Product Change Notice (PCN)

PCN Number: **PCN-0456243R-01**

Product(s) Affected: **SJ1-353XNS series. SJ1-3533NS, SJ1-3534NS & SJ1-3535NS**

PREVIOUS CUI DETAIL/IMAGE	NEW CUI DETAIL/IMAGE

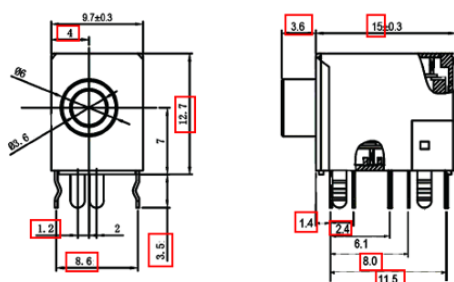
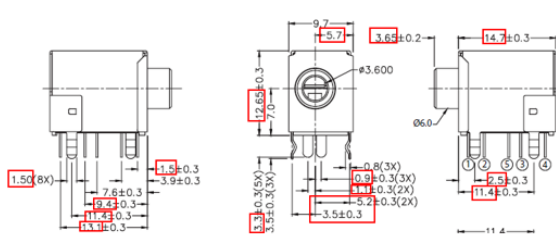
Description of Change: **New Factory Location. Product re-engineered for improved manufacturability and production yield. See image below for reference and check CUI Devices website for updated drawing. Cosmetic differences may be visible but will not affect the form fit and function of the product.**

<p>Recommended PCB Layout Top View</p>	 <p>Recommended PCB Layout Top View</p>

PREVIOUS CUI DETAIL/IMAGE			NEW CUI DETAIL/IMAGE		
DESCRIPTION	MATERIAL	PLATING/COLOR	DESCRIPTION	MATERIAL	PLATING/COLOR
terminal 1	brass	silver	terminal 1	brass	tin
terminal 2	phosphor bronze	silver	terminal 2	brass	tin
terminal 3	phosphor bronze	silver	terminal 3	brass	tin
terminal 4	brass	silver	terminal 4	brass	tin
terminal 5	brass	silver	terminal 5	brass	tin
spring	stainless steel	nickel	spring	stainless steel	
bushing	brass H59	nickel	bushing	brass	nickel
shield	SPCC t=0.30	nickel	shield	cold rolled steel	nickel
housing	PBT (UL94V-0)	black	housing	PBT (UL94V-0)	black
